#### Motorcycle braking – Global Technical Regulation No. 3

## Proposal for amendments to Global Technical Regulation No. 3 (Motorcycle brake systems)

### Submitted by the representative from Italy\*

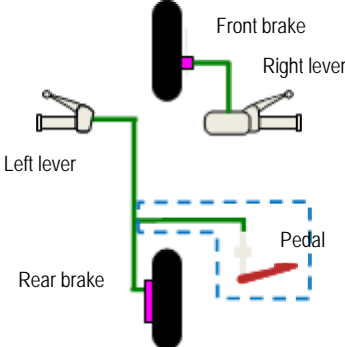
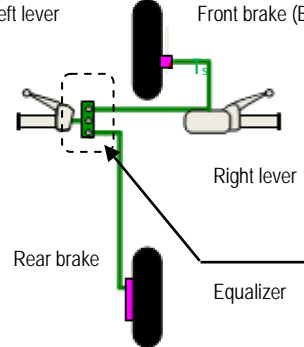
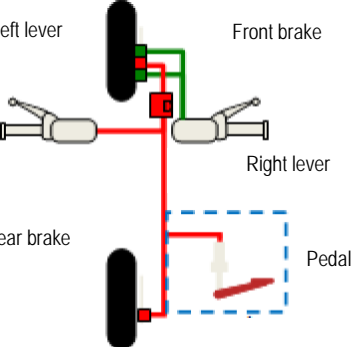
3. The current provision in UN GTR No. 3 (paragraph 3.1.9), requiring that "two separate brake systems may only share a common brake if a failure in one system does not affect the performance of the other", limits the application of CBS.

4. Not all CBS architectures can meet this requirement although they will outperform conventional brake systems.
5. Not all CBS architectures were, however, considered at the time the original CBS requirements were drafted in the 1980s and it is, therefore, understood that GRRF did not intentionally exclude such systems by introducing this requirement.

6. In order to ensure that, in case of a failure in one system, the performance of the other system still equals that of a conventional system, it is proposed to allow that two separate brake systems share a brake and/or a transmission, provided that the other system meets the single brake system performance requirements in case of a failure of such shared components(s). To that end, a failure test is proposed for CBS brake systems of Architecture B. Italy is of the opinion that such a failure test requirement should ensure the acceptance of such a CBS in terms of demonstrated robustness and guaranteed minimum braking performance.

<i>Conventional Brake System</i>	<i>Combined Brake System (CBS)</i>	
<i>Architecture A</i>	<i>Architecture B</i>	<i>Architecture C</i>

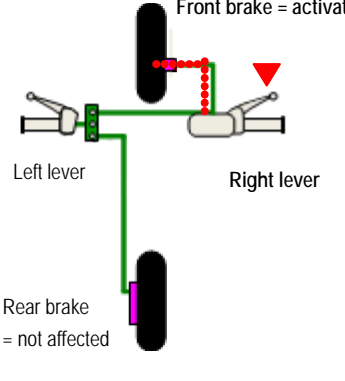
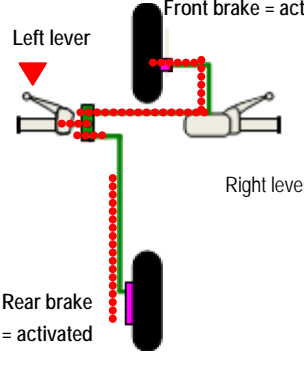
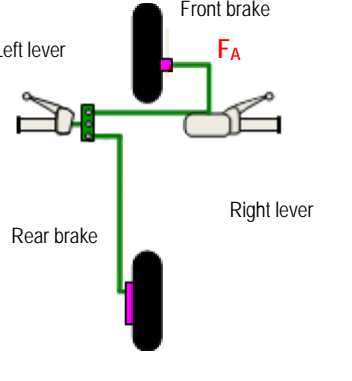
7. The current provision in UN GTR No. 3 (para. 3.1.9), requiring that "two separate brake systems may only share a common brake if a failure in one system does not affect the performance of the other", limits the application of Combined Brake Systems (CBS).
8. Not all CBS architectures can meet this requirement although they will outperform conventional brake systems.
9. Not all CBS architectures were however considered at the time the original CBS requirements were drafted (in the 1980s) and it is therefore understood that GRRF did not intentionally exclude such systems by introducing this requirement.
10. Architecture B is an example of a CBS that shares a transmission ( $T_s$ ) and a brake ( $B_s$ ).

12. In order to ensure that, in case of a failure in one system, the performance of the other system still equals that of a conventional system, it is proposed to allow that two separate brake systems share a brake and/or a transmission, provided that the other system meets the single brake system performance requirements in case of a failure of such shared component(s). To that end, a failure test is proposed for CBS brake systems of

Architecture B. Italy is of the opinion that such a failure test requirement should ensure the acceptance of such a CBS in terms of demonstrated robustness and guaranteed minimum braking performance.

"3.1.9 In cases where two separate service brake systems are installed, the systems may share a common brake, ~~if a failure in one system does not affect the performance of the other~~ **a common transmission, or both if the requirements of paragraph 4.12 are met.**"
